STATE OF NORTH CAROLINA
DEPARTMENT OF TRANSPORTATION

Minutes of Pre-Bid Conference

PROJECTS: WBS 33203.3.1 (B-3657) Haywood County Bridge No. 9

8/23/99

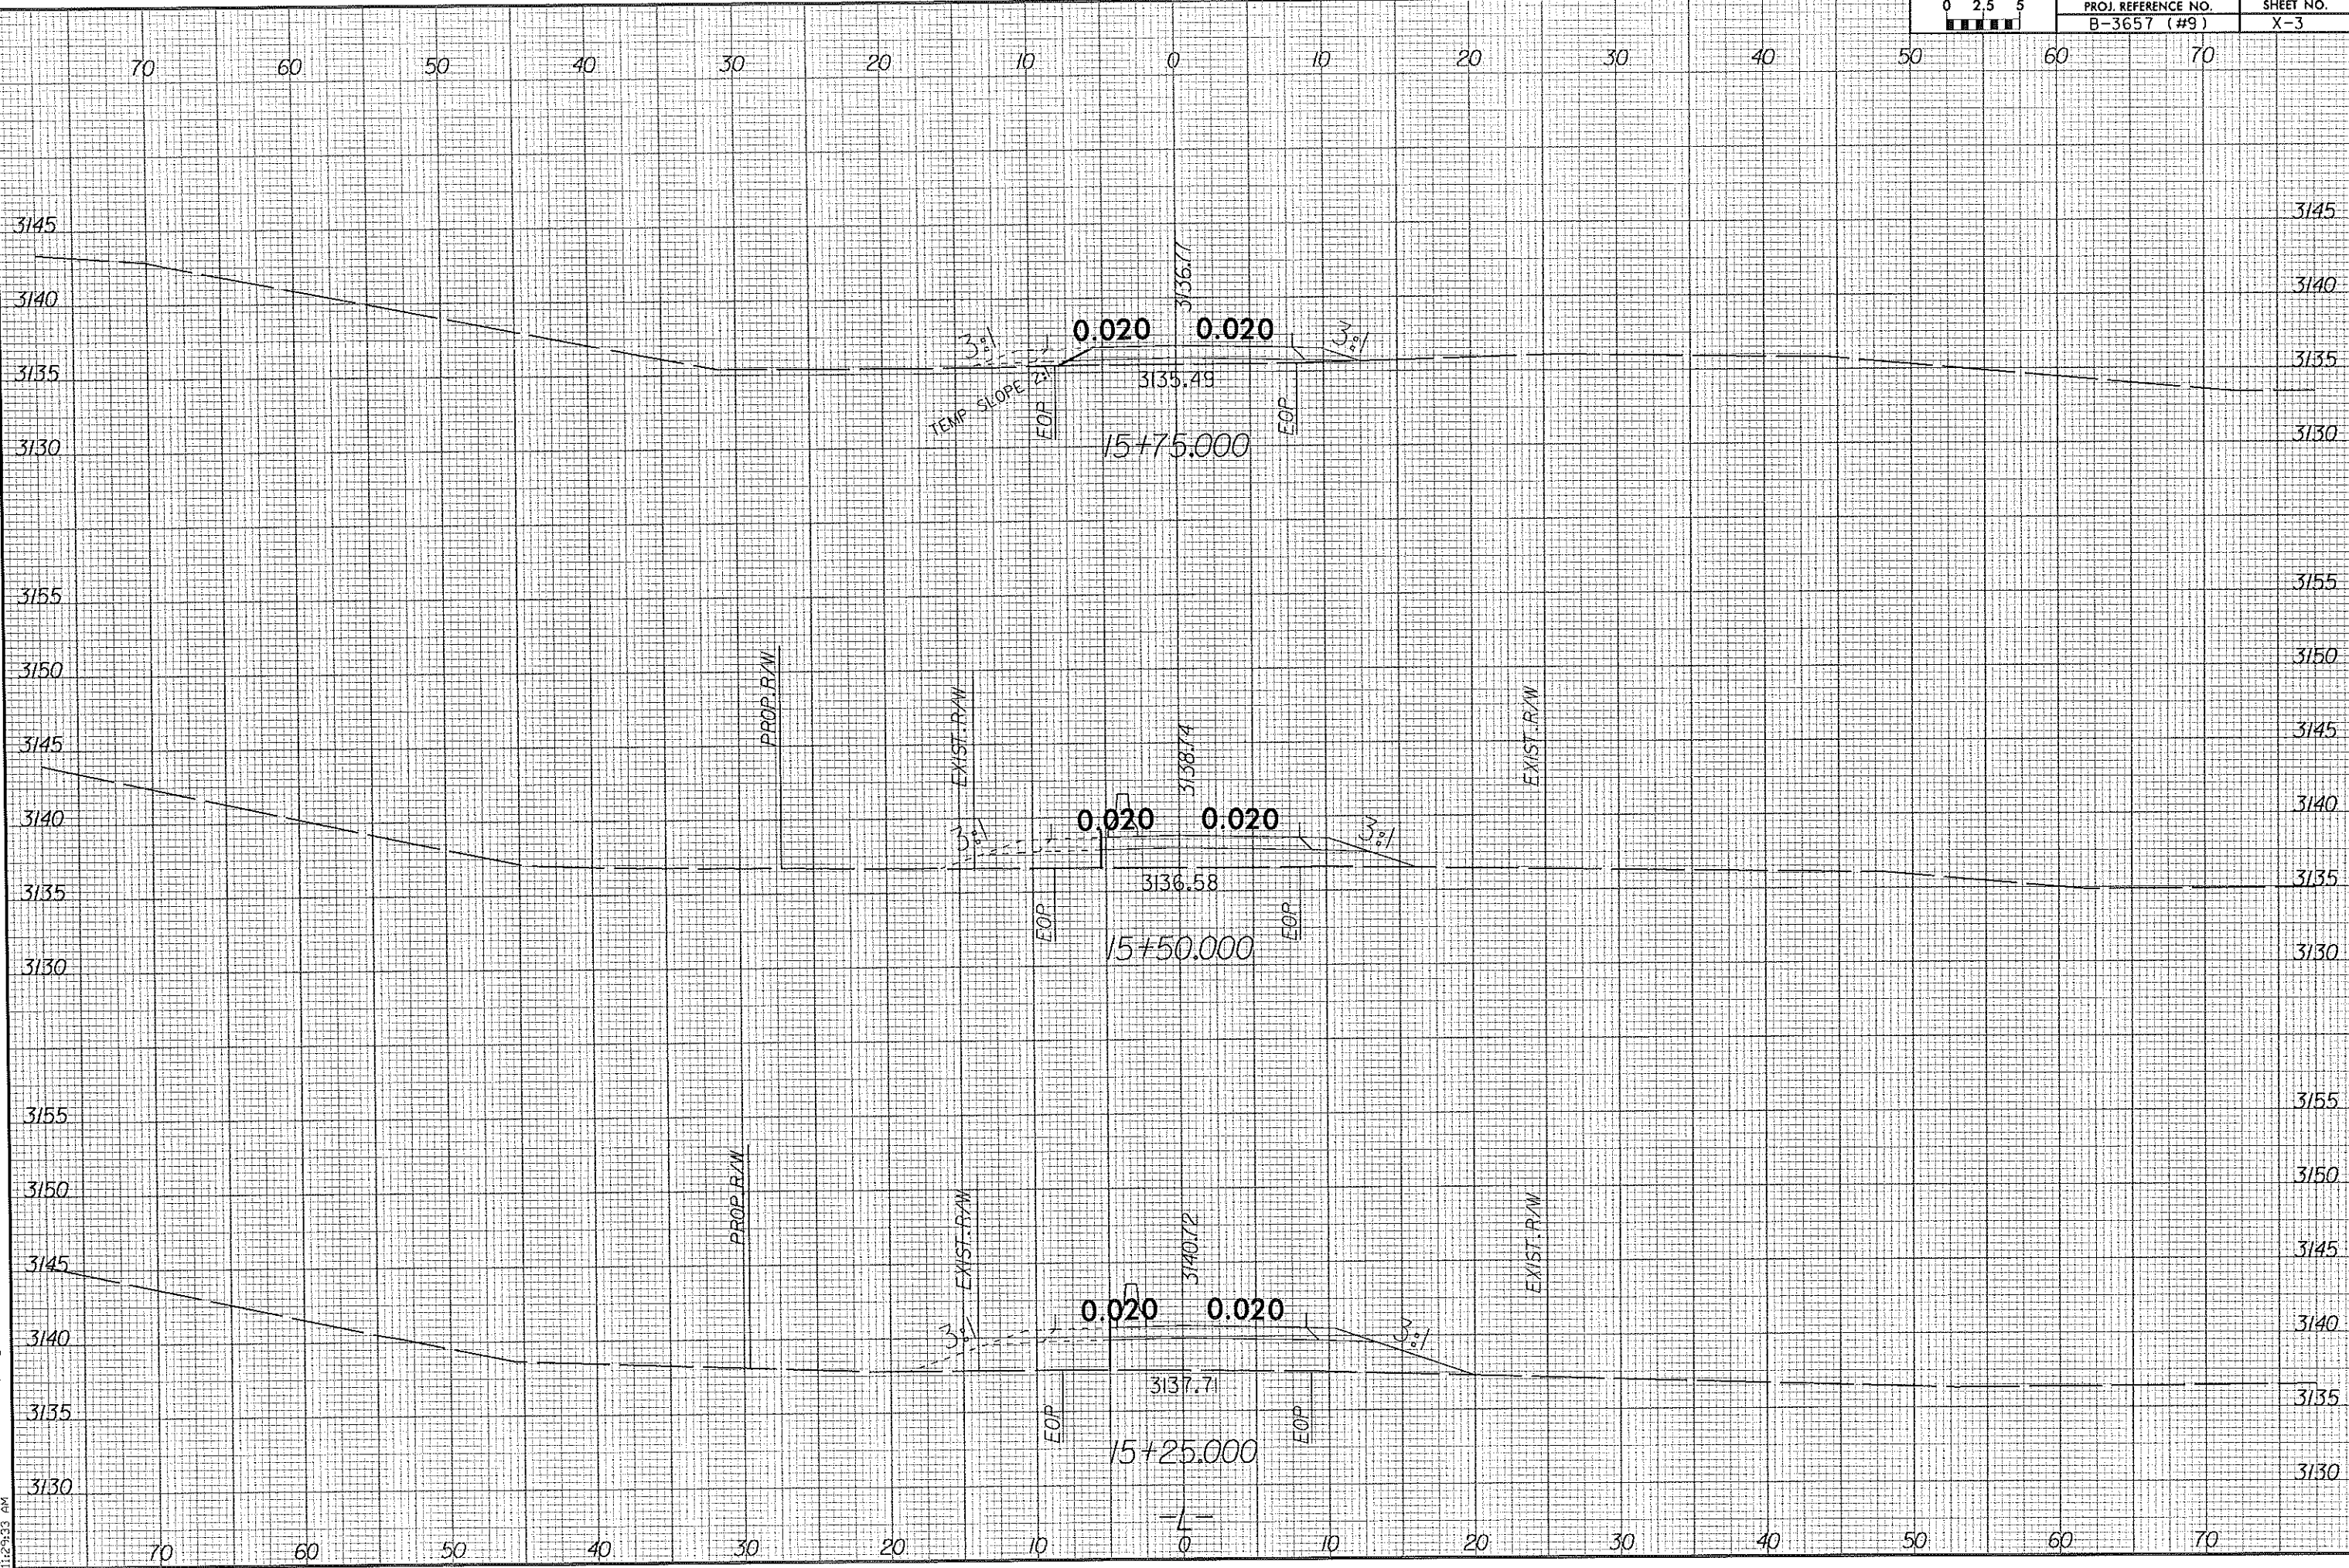
2. The contractors were informed that the backfill detail had been added to plans. Sheet no. 2 had been revised to show the 4” perforated drain pipe and outlet pad for the backfill. Based on contractor questions since the pre-bid meeting the limits of the temporary shoring have been revised on the end bent 2 side of the project. The revised plan sheet no. 2 and revised bid sheet are attached to these minutes.
